VARIATION OF BOOSTER TUNES WITH MOMENTUM

VARIATION OF BOOSTER TUNES WITH MOMENTUM (ADDENDUM)

January 28, 1970

Although the results of a previous note with the same title as above (FN-192) are correct when the magnet lengths are chosen to be identical with the design or comparison case (SYNCH), a small correction must be made for the reshaping of the closed orbits, if the magnet lengths are changed. This correction is included below.

FIG. 5

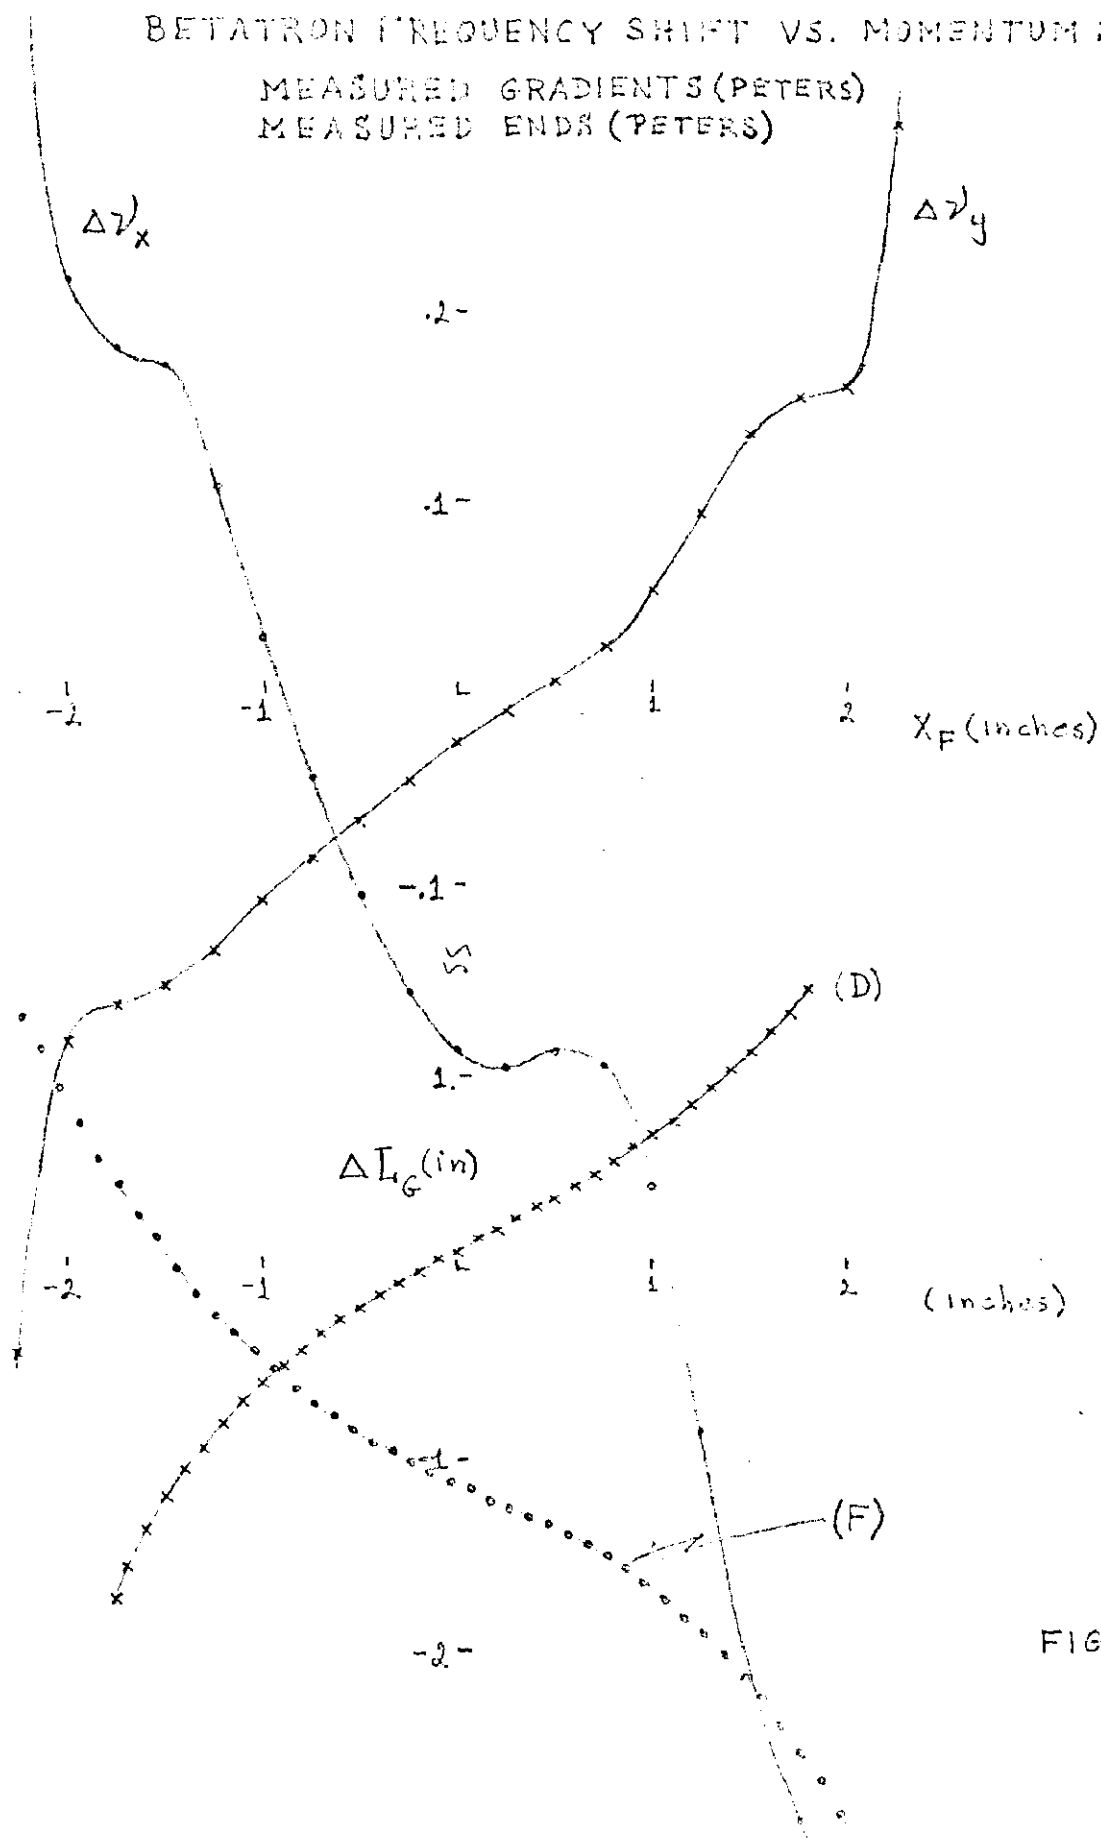
1. Figure 5 (FN-192) -- Δv_x and Δv_y are both lowered at all points by approximately 0.05.
